Service Bulletin No. 415B

MODEL	J4500 Series	TYPE	Field Change Program	SECTION/GROUP	7-Electrical	DATE	Sept. 17, 2014
SUBJECT	DD13 ENGINE REGENERATION AT LOW AMBIENT TEMPERATURE						
CONDITIONS

THIS BULLETIN SUPERCEDES FIELD SERVICE BULLETIN 415 IN ITS ENTIRETY.

Figure 3.

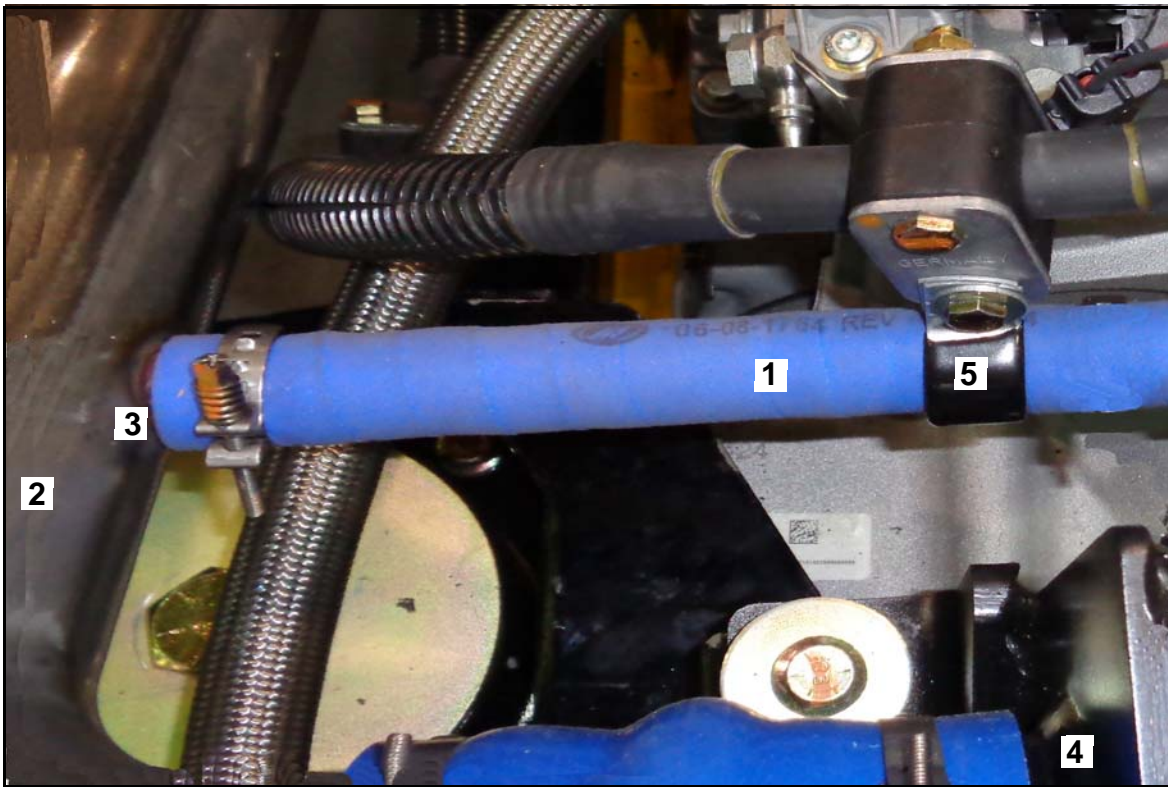
8. Locate the coolant hose (refer to Item 1 / Figure 3).
9. Locate the coolant hose line clamp (refer to Item 5 / Figure 3). Remove and retain the line clamp and mounting hardware.
10. Using a marker and tape measure, mark a line at the 9.50 and 14.00 inch point using Item 3 / Figure 3 as the starting point.

11. Using hose cutters and wire cutters, cut the hose jacket and wire framing at the lines made in Step 10. Discard the cut piece.

Item	Description
1	Coolant hose
2	SST Pipe, Oil Cooler to Thermostat
3	Measurements, 9.50 and 14.0, inch, to be taken from this point
4	Transmission cooler, reference location
5	Remove and retain line clamp and mounting hardware

12. Orient the coolant bypass valve, p/n 16-16-1616, ensuring that the casting stamped "IN" port is facing towards the curbside of the coach. Slide one (1) stepless spring clamp, p/n 19-4-230, over both ends of the cut hose end. Install the valve utilizing the cut hose ends as shown in Figure 4. Orient and tighten the stepless spring clamp over the valve ports. Torque clamps to 12-14 in.-lbs.
13. Re-install the coolant hose line clamp (refer to Item 5 / Figure 3).
